STRATHFIELD LOCAL PLANNING PANEL MEETING AGENDA

Thursday 28 March 2024

TO: Strathfield Local Planning Panel Meeting - 28 March 2024
 REPORT: SLPP – Report No. 4
 SUBJECT: DA2023/52 - 5 STRATHFIELD SQUARE, STRATHFIELD - LOT 1 DP 433421
 DA NO. DA2023/52

Figure 15: Easter Façade Zig Zag setback pattern

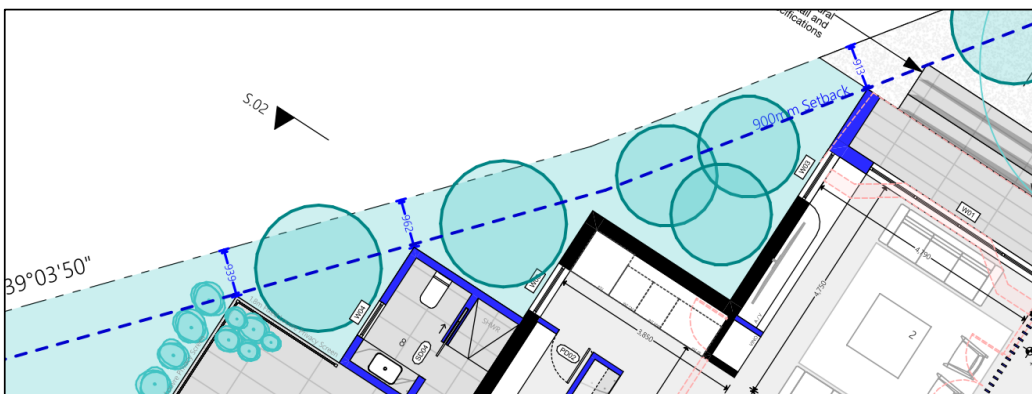
The eastern side setback, at a minimum of 0.913m, also does not meet the minimum 1.2m requirement. However, the eastern façade setbacks are all point encroachments as the development is articulated in a zig zag pattern along the eastern boundary (see **Figure 15**). Therefore, these encroachments are unlikely to cause significant impact as they are staggered along the eastern boundary with some parts of the built form having a larger setback. Accordingly, the variation is considered acceptable.

The pool has a point encroachment with the eastern boundary line that does not meet the 1m setback requirement, being only 0.939m (see **Figure 15**). This is a negligible non-compliance which is unlikely to impact on adjacent properties given any impacts are mitigated by the privacy screen. Landscaping has also been added between the pool coping and the boundary. Overall, the pool and its design are acceptable in this circumstance.

Figure 20: Southern Elevation showing excavated rear yard

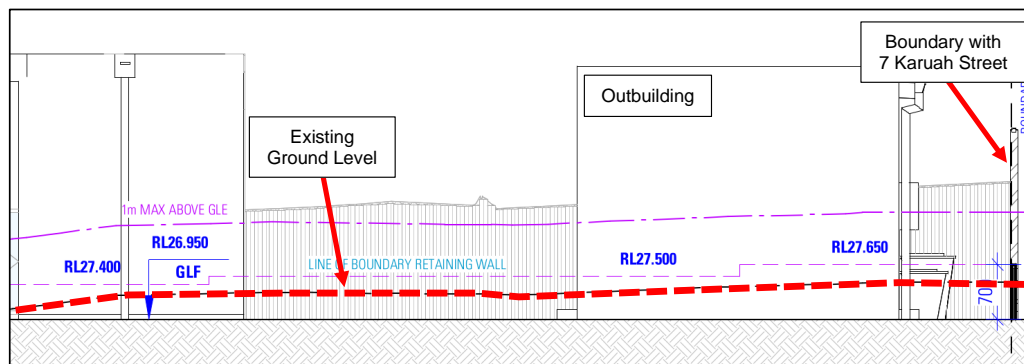
As per the South Elevation, almost the entire rear yard will be excavated up to a depth of 0.5m (see **Figure 20**). While the desire for consistent external levels is appreciated, this does not justify the extent of excavation proposed nor its proximity to the adjoining property. The proposed in-ground swimming pool further increases excavation on the site.

The design is not considered to minimise excavation risk, particularly when the site is designated as flood prone. The unnecessary volume of excavation has the potential to contribute to cumulative adverse ground water and soil stability impacts. Accordingly, the proposal is considered inconsistent with Clause 6.2 of the SLEP 2012.

Figure 23: First Floor Plan showing locations of proposed voids (highlighted in yellow)

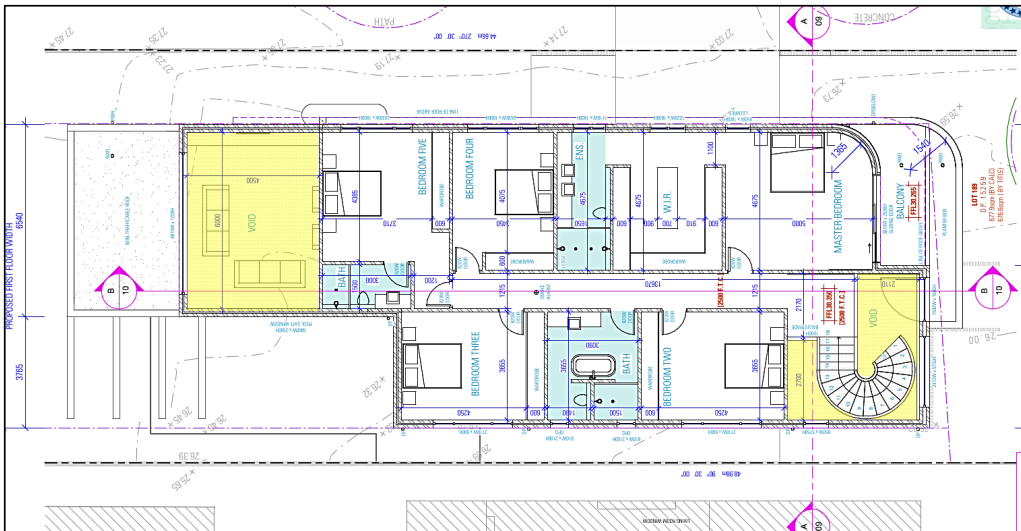
The majority of the proposal complies with the 3m maximum floor to ceiling height provision in the SCDP 2005. The ground floor provides 2.7m and the first floor 2.5m. However, there are two voids which breach the control. The first is a smaller area around the entry stairwell at 5.75m and the second is an 27m² area above the living area at 4.75m (see **Figures 23 and 24**). These non-compliances are discussed as part of the broader building envelope assessment below.

Figure 25: Proposed Karuah Street (South) Elevation

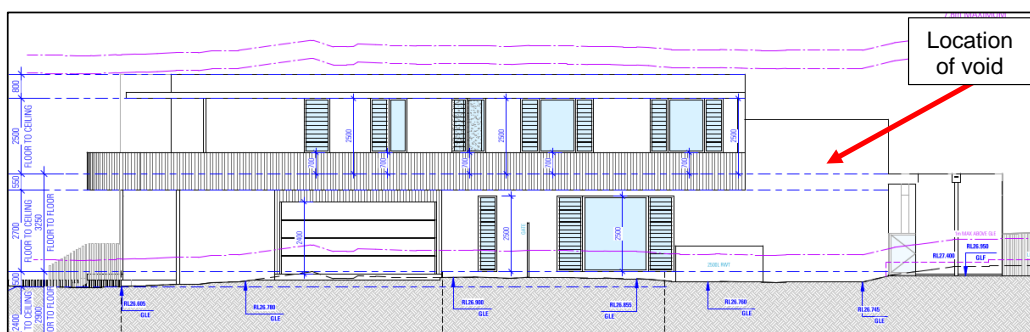
The void over the living room has a lower ceiling than the rest of the roof, however continues to create significant bulk to the rear which is readily visible from the street. The void seems unnecessary when the living room has adequate solar access to the east and north. No northern opening is provided for the void which one would assume is where the maximum amenity could be derived. It adds excessive bulk to the streetscape presentation. The area of the void will appear as a blank wall to the street (see **Figure 25**).

Figure 26: Site plan showing front setback breach

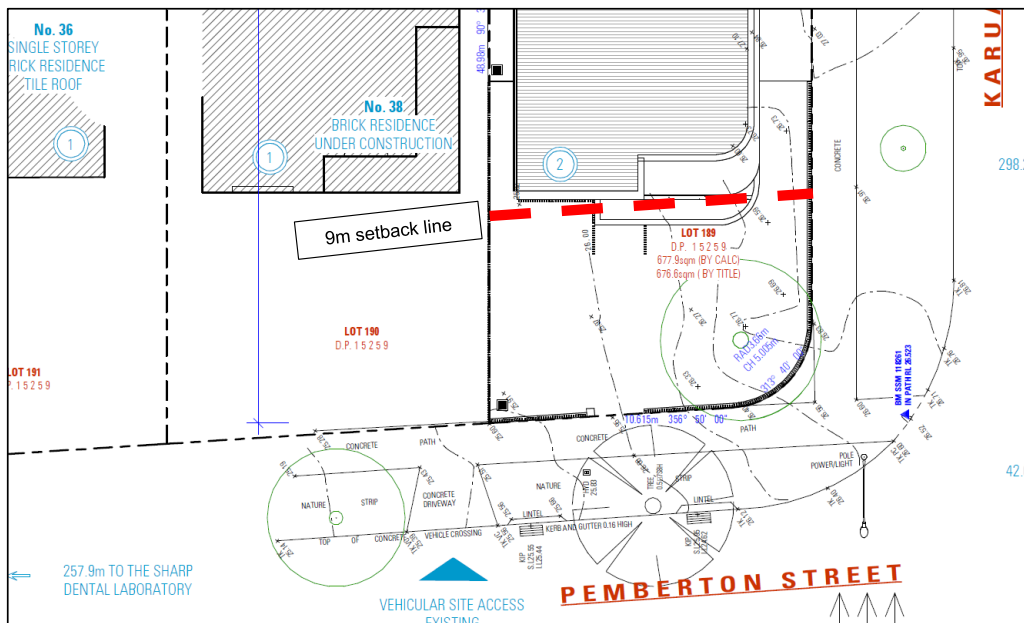
The front setback is non-compliant with the SCDPC 2005 requirement of 9m. There is an 8m setback from the first storey planter box (see **Figure 26**). Although a minor non-compliance, it still contributes to the bulk of the development. It also clearly protrudes further than the two neighbours to the north.

These non-compliances contribute to the excessive bulk and scale of the development. The accumulation of all the non-compliances means that, overall, the development is of a bulk and scale that is unacceptable for the site and the streetscape.

Figure 27: Front fence elevation showing increase to 1.8m

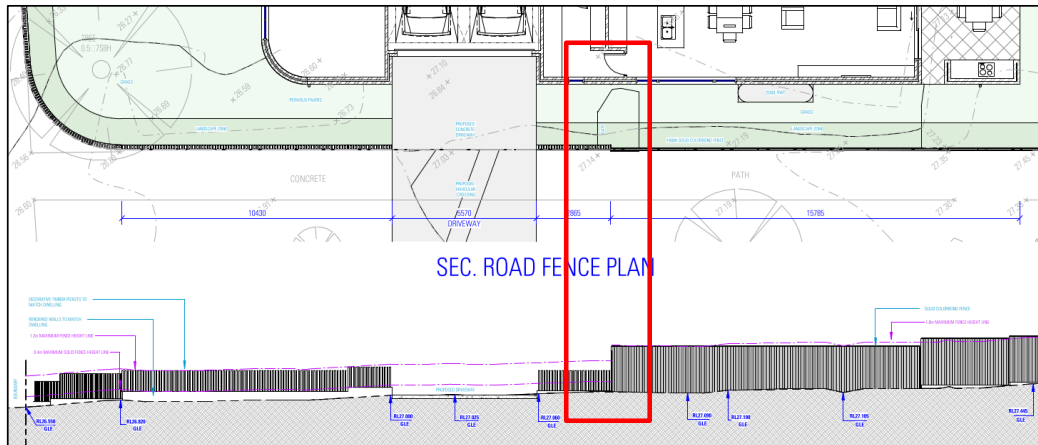
The primary fencing along the primary and secondary frontages satisfies the relevant controls within SCDCP 2005. The maximum height will be 1.2m with a 0.4m solid component which complies with the 1.5m and 0.7m maximum controls respectively. However, the fencing along the Karuah Street frontage extends up to 1.8m high in line with the kitchen (see **Figure 27**). The SCDCP 2005 anticipates an increase but only beyond the rear building line with the express purpose of providing privacy for the rear yard. The solid fence will not integrate well with the open paling fence of the adjoining 7 Karuah Street. This non-compliance forms a reason for refusal.

Figure 28: Proposed North Elevation showing bedroom window sill heights

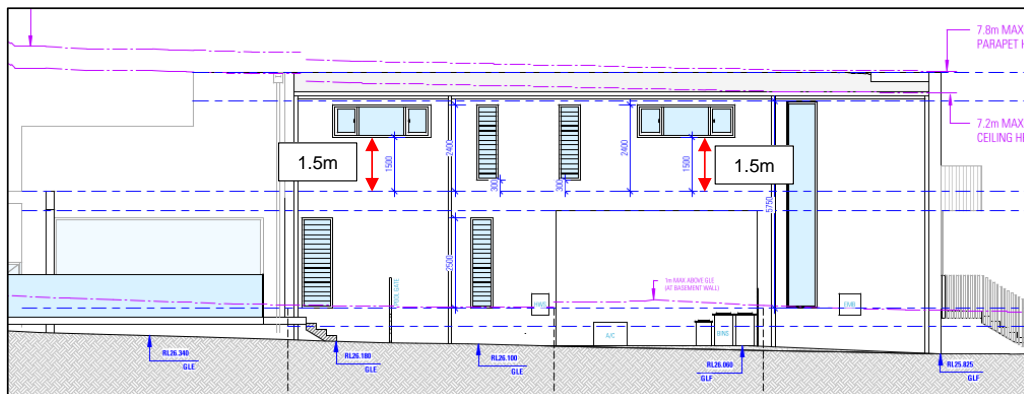
While the northern elevation is raised above existing ground level, which ordinarily creates ground floor sightlines over the side boundary, in this case there are no habitable ground floor windows along the side boundary. The only windows are from the stairwells and powder room. The living room is well stepped back behind the pool. On the upper level, the only habitable windows are from the bedrooms. These have a sill height of only 1.5m which does not sufficiently prevent sightlines (see Figure 28).

Figure 29: Proposed First Floor Plan showing insufficient horizontal offset from adjoining property

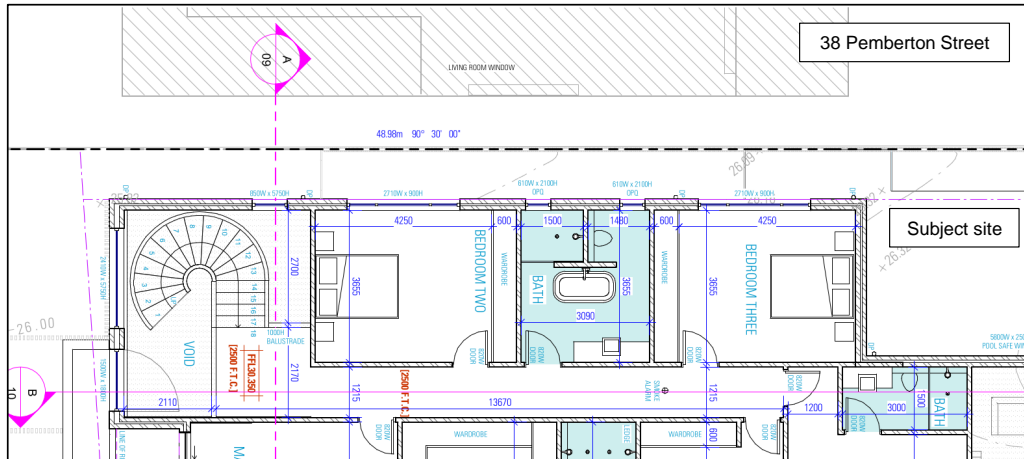
The Bedroom 2 window does not appear offset 500mm from the adjoining windows, however, there is insufficient information to demonstrate this definitively (see Figures 29 and 30). Figure 29 does not indicate all the windows or the current built form of the adjoining development as per Figure 30. It incorrectly references a living room window and appears to

be based on a previous development. The large neighbouring window in **Figure 30** services a bedroom. Given, the proposal only provides a 1.2m upper level setback to the north, there will be a significant privacy impact into this room. This forms a recommended reason for refusal. Privacy from the outbuilding is discussed in the relevant outbuilding section below.

Figure 31: Ground Floor Plan showing areas of potential sightlines from pool area

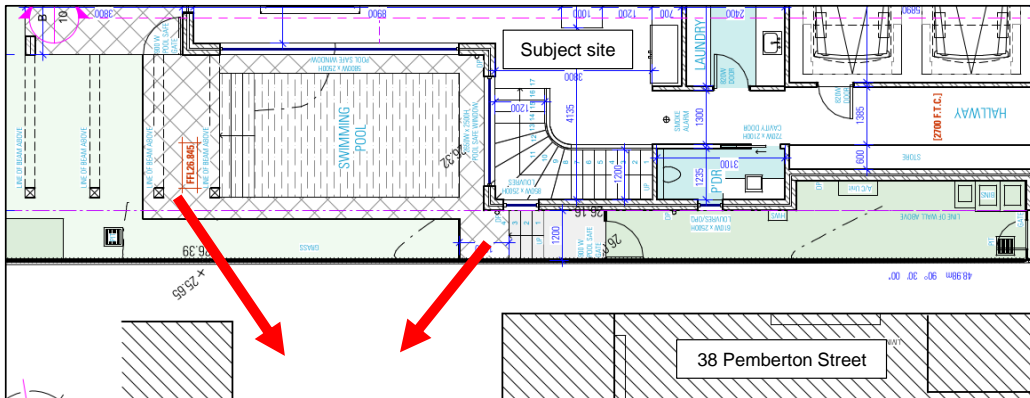
The pool coping is approximately 0.52m above the existing ground level at its highest point (based on existing RL26.32 indicated on drawings). The raised pool area increases aural and visual privacy impacts given, at this height, the boundary fence is insufficient to prevent downward sightlines. It seems possible for a person to stand on the eastern pool landing area and overlook the side boundary fence to the north (see **Figure 31**). This scenario is exacerbated along the northern side boundary where it appears possible to look directly over the fence. This forms a recommended reason for refusal, being inconsistent with Section 9.2(8) of Part A of the SCDP 2005.

Figure 32: Southern Elevation showing retaining wall beyond property boundary

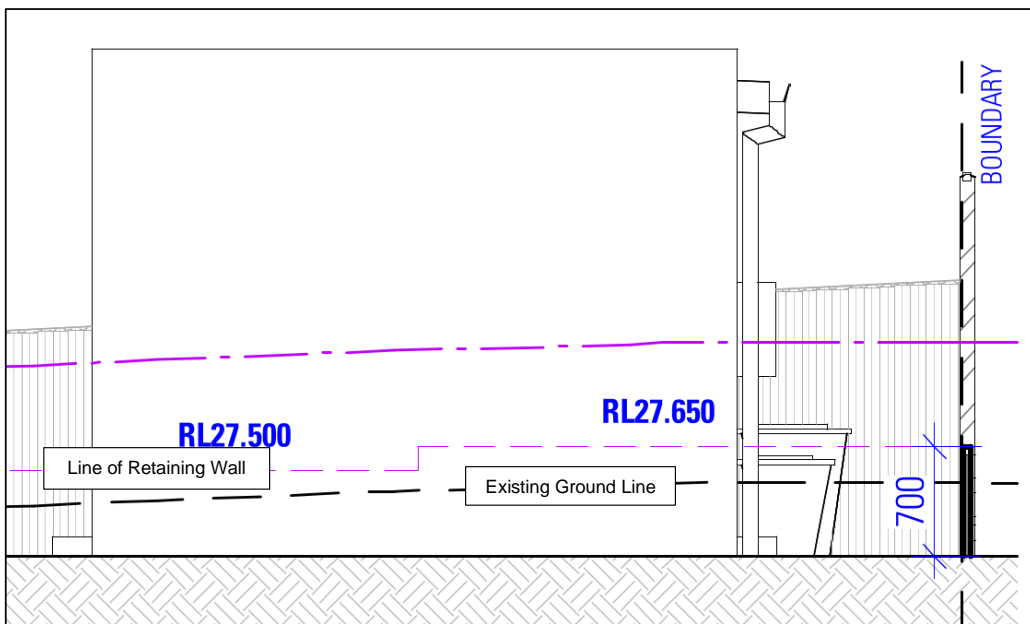
The proposal appears to provide a 0.7m retaining wall to the eastern boundary with 7 Karuah Street (see **Figure 32**). This is to retain the adjoining property's soil given the subject site will be excavated to allow for the proposed outbuilding. The 0.7m height complies with the maximum height of 1.2m, however, it would require to be designed by a suitably qualified engineer.

Of greater concern however is that this retaining wall appears at or beyond the property boundary and no owner's consent from 7 Karuah Street is provided (EPA Regulation 2021, s 23(1)). This forms a recommended reason for refusal.

Figure 3: S8.2 Review Basement Plan

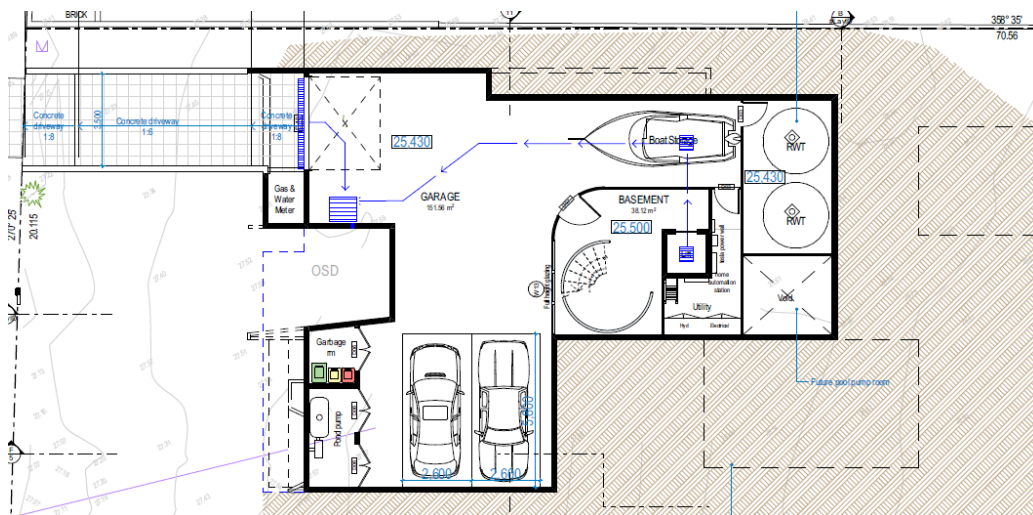
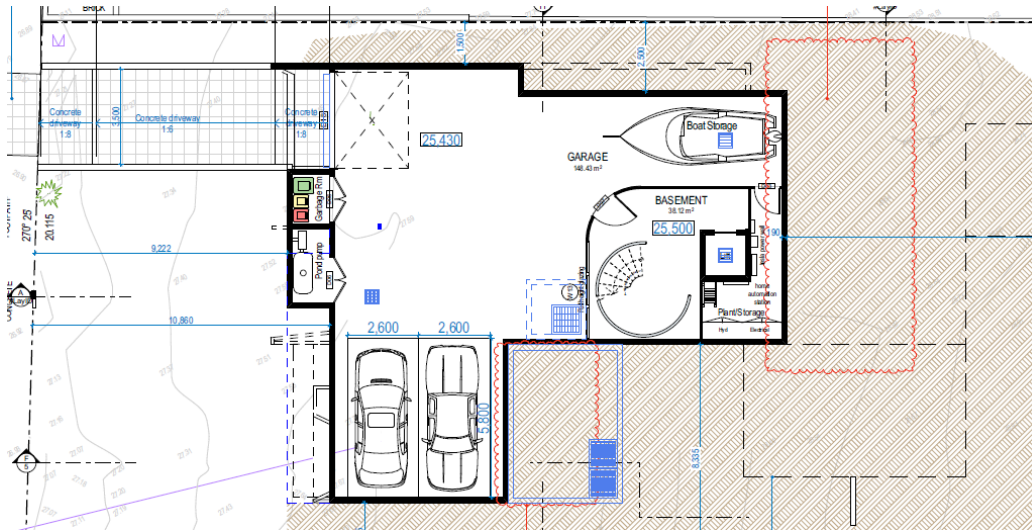
The basement area has been reduced from the previous application. The excessive excavation for rainwater tanks and future pool pump room have since been deleted and the car spaces brought forward and utility rooms have been moved to the previous OSD void. Whilst there is a minor encroachment of the basement outside the ground floor footprint (under the porch area) this is minor and reduces the depth of the basement and helps limit the excavation within the basement, which is considered acceptable and the minimum amount required to provide for the required number of parking spaces, manoeuvring areas, utility areas and internal access.

Figure 5: s8.2 Review Ground Floor Plan

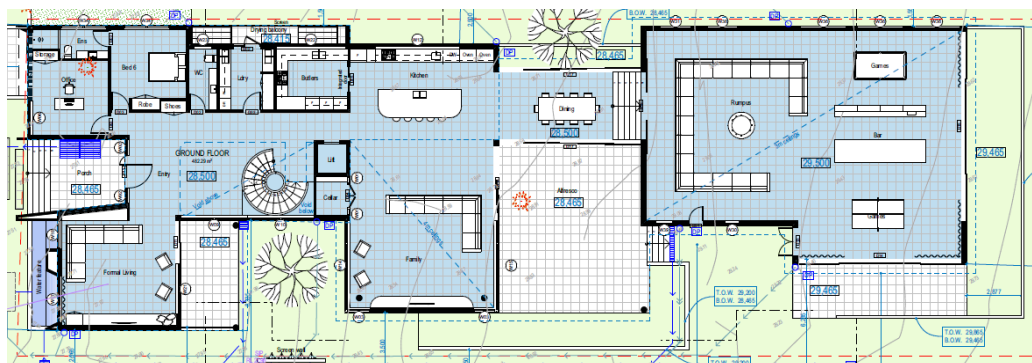
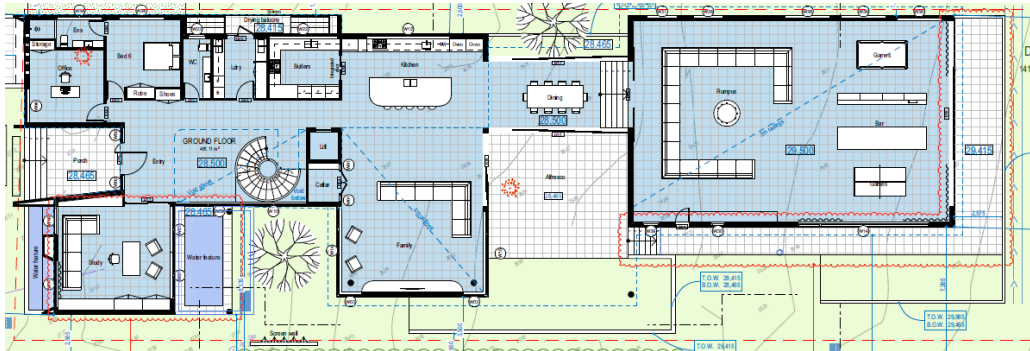
The rumpus room has been reduced in size and area, it has now rectangular in shape and a paved walkway has been added around the eastern and northern ends. The alfresco area has been reduced and increased setback from the side boundary. The formal living room has been changed to a study room and the elevated courtyard outside the living room has been converted to a water feature. These changes have addressed a number of concerns with the original proposal. The development now complies with the FRS controls, potential privacy impacts from the elevated courtyard have been removed, which also then negates the need for the privacy screen on the eastern elevation.

Figure 10: s8.2 Review – East Elevation

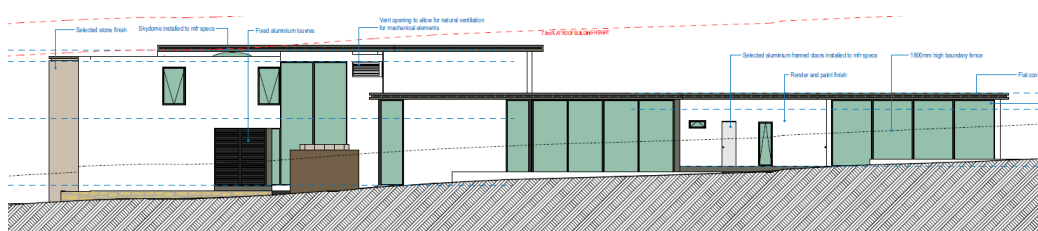
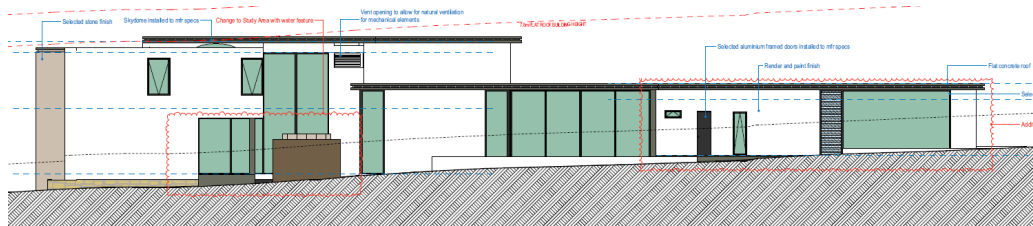
The eastern elevation is also acceptable in terms of privacy. The adjoining property at 81 Newton Road is single storey. Ground level sightlines will be obscured by the boundary fence. Privacy concerns were originally raised in relation to the raised formal living room and courtyard. The s8.2 plans have converted the raised formal living area and courtyard to a study room and water feature, removing any privacy concerns to the adjoining property at 81 Newton Street.

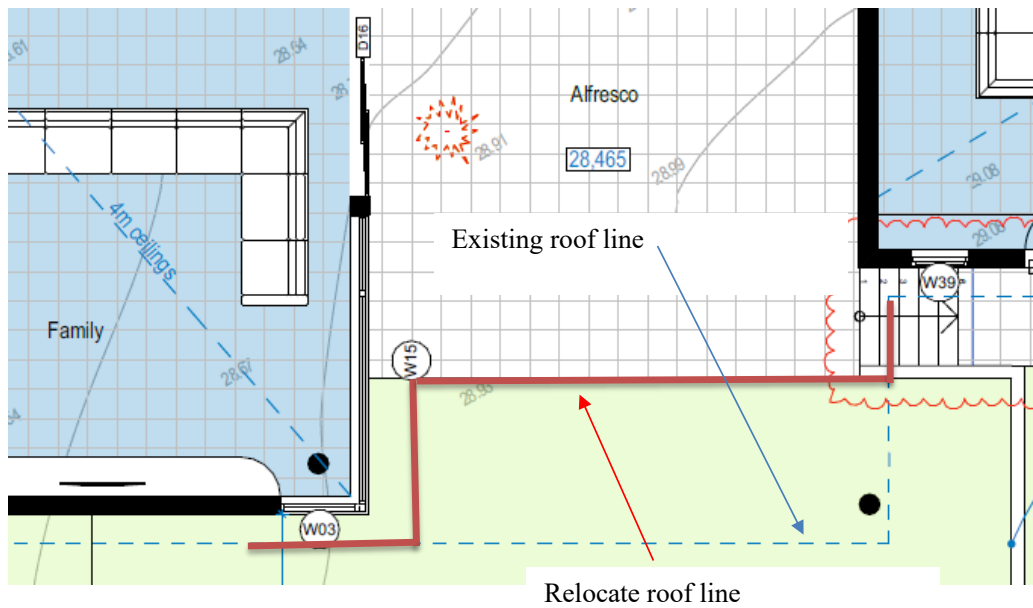
While the front façade complies, there will be a minor 0.3m exceedance of the flat roof dwelling height control for a small portion of the pop-up roof form further into the site (see **Figure 18** below). The extent of this had been significantly reduced at the previous request of Council. There will also be a 0.1m parapet height breach.

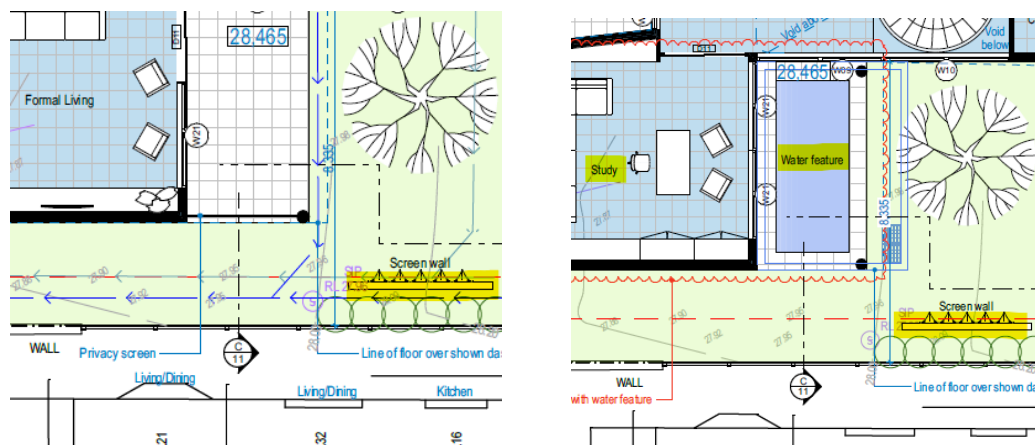
The western elevation is acceptable in terms of privacy. The ground floor includes fixed louvers for the drying area and obscure glazing for the kitchen. Bedroom 6 at the front and its

accompanying ensuite are located forward of the adjoining building line (85 Newton Road). Given the underlying topography, the side boundary fence should block direct sightlines from the Dining Room while the Rumpus Room windows are generally highlight. These are behind the building line of the adjoining property.
